APPENDIX 2:

AMENDMENTS TO THE APPLICATION

BP Mosgiel Response to further information request

BP CONNECT MOSGIEL
SITE REDEVELOPMENT BP CONNECT SHOP,
8 LANE CANOPY, CARWASH AND SITE WORKS

Figure 1 Updated proposed site plan

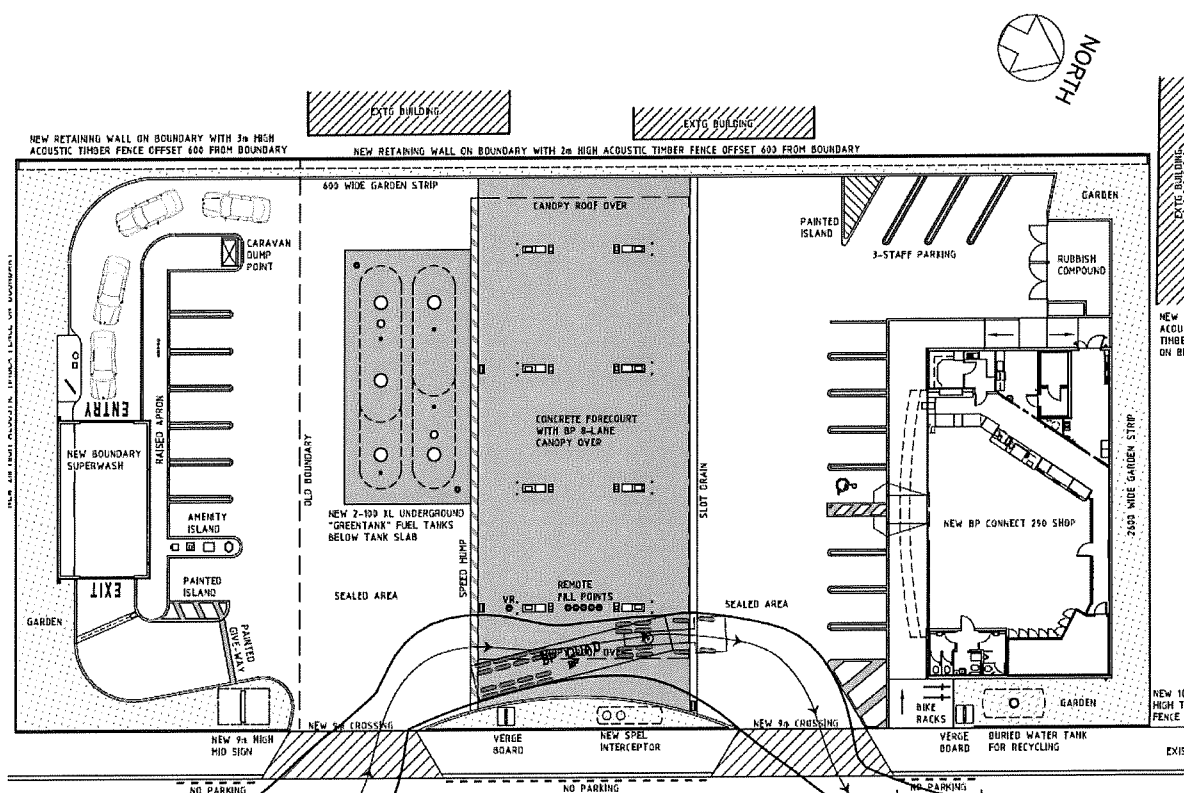
Following preparation of the SLR report it is understood that the property owners to the west of the site have requested the boundary fence to be altered (brought into the site by 600 mm and, in one location, increased in height to 3 m). Accordingly BP has made these alterations, as shown in Plan 3ALC1-14 Rev H (**Figure 1**).

3ALC1-14	J
----------	---

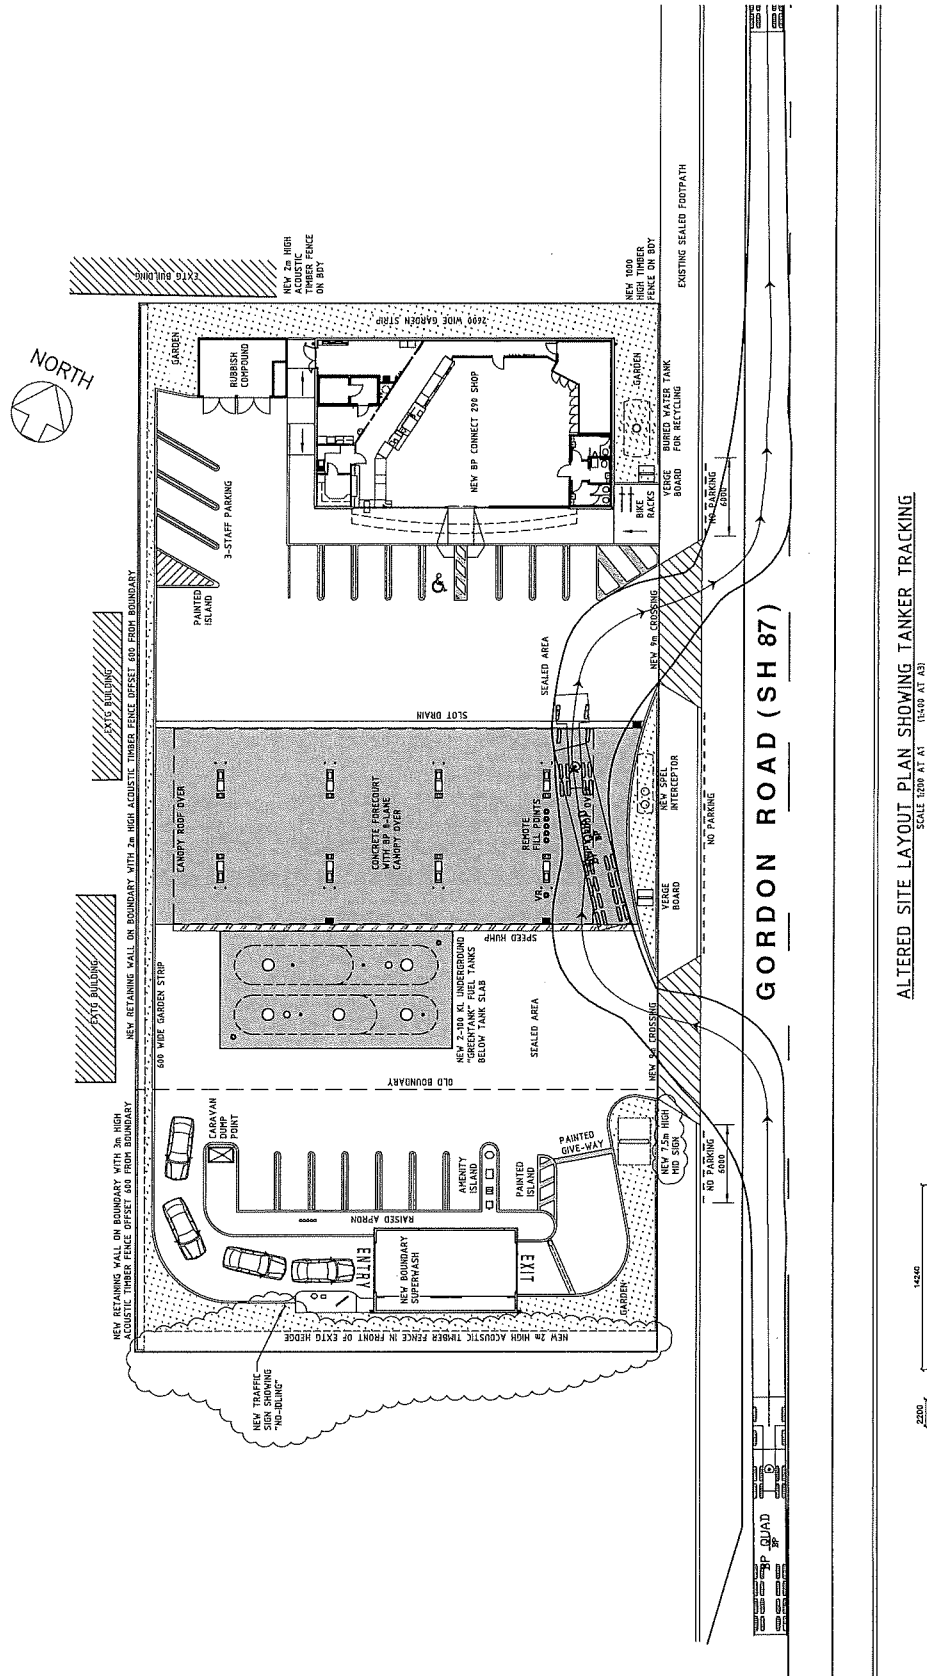
As previously advised, BP have amended the proposed site layout by moving the rear acoustic boundary fence into the site by 0.6m. This is as a result of consultation with the affected neighbours on this boundary. The height of the fence has also been increased to 3m adjacent to 41A Irvine Street at the request of the owners of 2 Mure Street. These changes are shown on the attached amended plans which we seek replace the plans which were lodged with the application.
